**PLANNING DEPARTMENT
CURRENT PLANNING STAFF ANALYSIS
PLATTING**

DATE: August 3, 2022

CASE: S12671
Irene Heights Subdivision, Lots 1-5
Subdivision of one (1) tract into five (5) lots.

Groundwater Photo Survey
Location Key

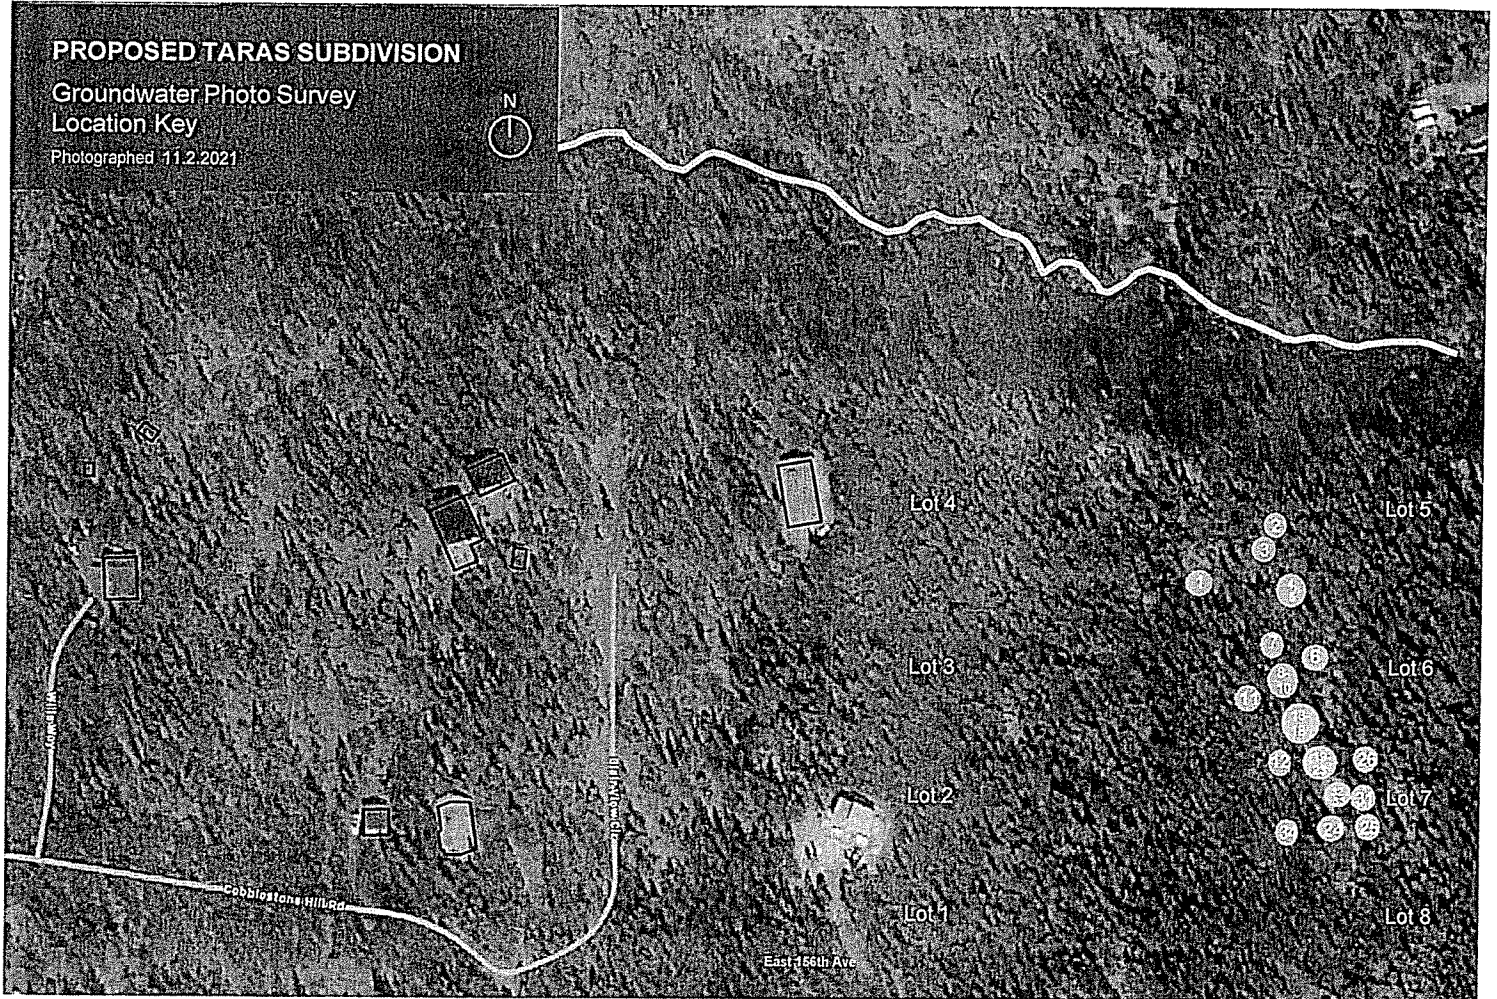
- B. We recommend that an additional drawing be required with the site's topography overlaid with the proposed property lines; this figure should also show where the anticipated building, well, and septic sites are proposed. This figure will help the public and staff to see whether Title 21.08.030 (for development on steep slopes) applies.

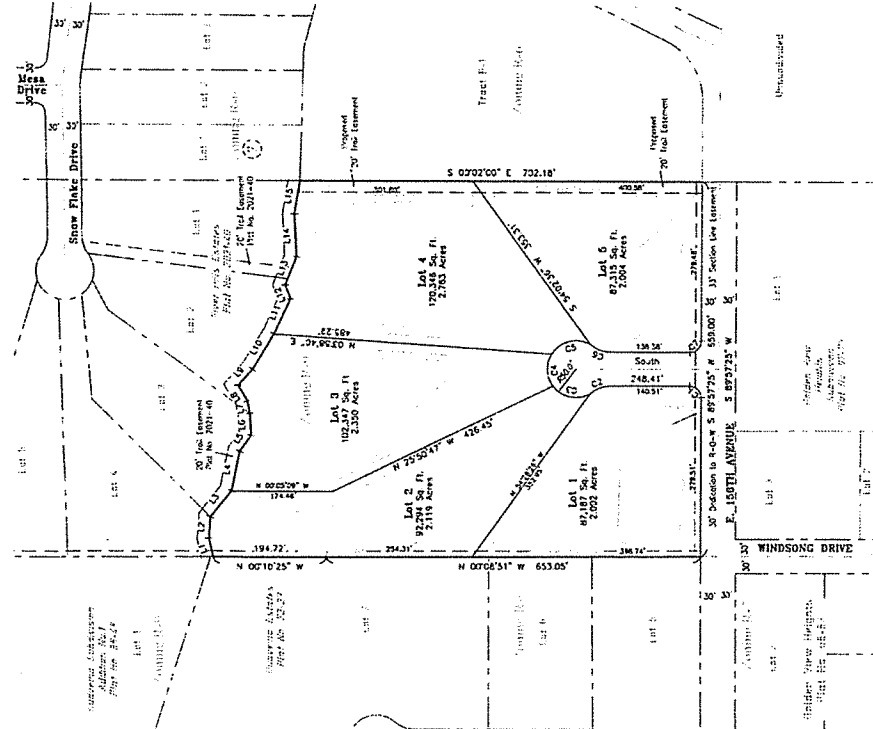
2. **Addressing:**
 - a. In the platted area:
 - i. Street name is Snow Flake (at this location) please correct label.
 - ii. Street name is Mesa Place (not Drive), please correct label.
 - iii. Street name is Wind Song Dr (not Windsong Dr), please correct label.
 - iv. NEW proposed street must be named with a unique name. The street Type will be Circle. You may visit the Addressing website for existing names for the proposed subdivision <https://streetnamesmasterlist.muni.org>, but please also contact Addressing for approval. addressing@muni.org or 907-343-8466
 - v. Lot 2' & 3 River Hills Estates was recently subdivided. Plat 2022-22, and is now Lot 2A, please update to current legal
 - vi. There seems to be two preliminary subdivision names between all documents. Please verify the name proposed for the subdivision. You may need to submit correction so everything will match.

10. Make the following drafting changes:
 - a. In the platted area:
 - i. Street name is Snow Flake (at this location) please correct label.
 - ii. Street name is Mesa Place (not Drive), please correct label.
 - iii. Street name is Wind Song Dr (not Windsong Dr), please correct label.
 - iv. New proposed street must be named with a unique name. The street Type will be Circle. You may visit the Addressing website for existing names, <https://streetnamesmasterlist.muni.org> , but please also contact Addressing for approval. addressing@muni.org or 907-343-8466.
 - v. Lot 2 & 3 River Hills Estates was recently replatted, Plat 2022-22, and is now Lot 2A, please update to current legal.
 - vi. There seems to be two preliminary subdivision names between all documents. Please verify the name proposed for the subdivision. You may need to submit correction so everything will match.

- a. In the platted area:
- i. Street name is Snow Flake (at this location) please correct label
 - ii. Street name is Mesa Place (not Drive), please correct label
 - iii. Street name is Wind Song Dr (not Windsong Dr), please correct label
 - iv. NEW proposed street must be named with a unique name. The street Type will be Circle. You may visit the Addressing website for existing names, <https://streetnamesmasterlist.muni.org> , but please also contact Addressing for approval. addressing@muni.org or 907-343-8466
 - v. Lot 2 & 3 River Hills Estates was recently replatted, Plat 2022-22, and is now Lot 2A, please update to current legal
 - vi. There seems to be two preliminary subdivision names between all documents. Please verify the name proposed for the subdivision. You may need to submit correction so everything will match.

1. Lots 1 & 5: Add S10' T&E easement.
2. Lots 1 & 2: Add W 10' T&E and 10' wide T&E on each side of the common lot lines.
3. Lots 3 & 4: Add 10' wide T&E each side of lot lines, beginning at the South common corner of said lots, running North for a distance of Three Hundred Feet (300').
4. Lots: 1-5: 10' wide T&E around perimeter of the cul-de-sac at the road frontage.
